Zoning Board of Appeals
Wednesday, September 11, 2024
5:30 PM

- 2. ZBA 2024-008: Design Review** for Approval of a **556 SF Addition** at **New Life Tabernacle Church** located at **54XX Reimer Drive** (PIN: 04-33-128-009).
[Property Owner: New Life Tabernacle]
- 3. Discussion and review** of current regulations relating to **Sec. 15-555 Private Solar Energy Collection Systems**

Zoning Board of Appeals Meeting of September 11, 2024**Application No. ZBA 2024-008****To:** Village of Roscoe Zoning Board of Appeals**From:** Evan Hoier, Vandewalle & Associates – Village Consulting Planner**Date:** August 20, 2024**Re:** New Tabernacle Church Meeting Hall Addition**Background**

DRAWING 00424A3	ADDITION AND REMODELLING FOR: REV. PATRICK GILES	PROJECT 004-24
DATE 07.30.24	NEW LIFE TABERNACLE MEETING ROOM	SHEET A3
REVISED	5400 REIMER DRIVE	OF 5
STEVEN M. PAPESH AND ASSOCIATES, P.C. ARCHITECTS		
5477 BROAD STREET ■ ROSCOE, ILLINOIS 61073 ■ PHONE/FAX 815.623.6499

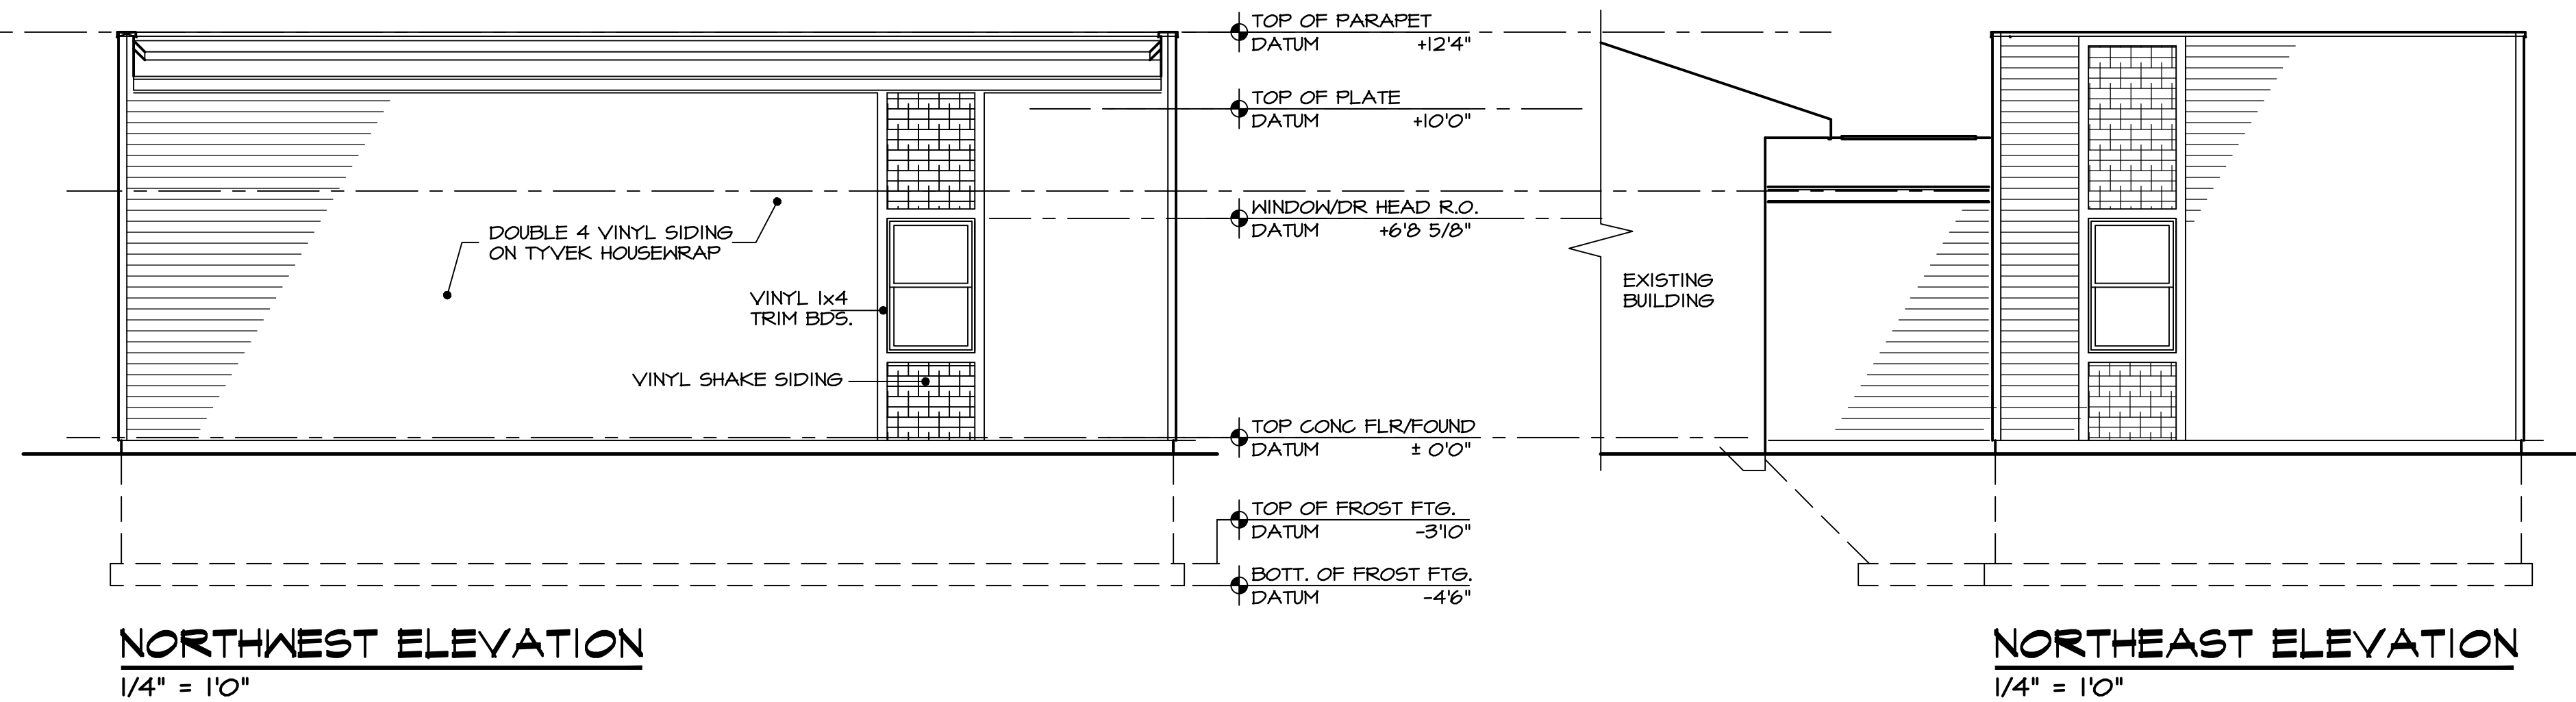
The proposed addition will be 556 square feet, connected by a walkway between the existing building and the proposed area. This walkway will have a gabled roof connected into the existing building's roofline, perpendicular to the main pitch. The majority of the addition will be sided by Double 4 vinyl siding to match the siding on the existing building. Also to match, the shingles on the addition will match those on the existing roof.

There are 2 windows on the addition, one on the northwest elevation, the other on the northeastern elevation. These windows will have vinyl shake siding above and below them to match the windows on the elevations of the existing building. The elevations provided by the applicant do not show any color variations planned. As a condition of approval, any

and all elements of the exterior of this proposed addition must be consistent with colors on the existing building.

1. Color selections on the proposed addition must match those on the existing meeting hall building.
2. Additional or replacement siding on the existing dumpster enclosure in the site's front yard is required.
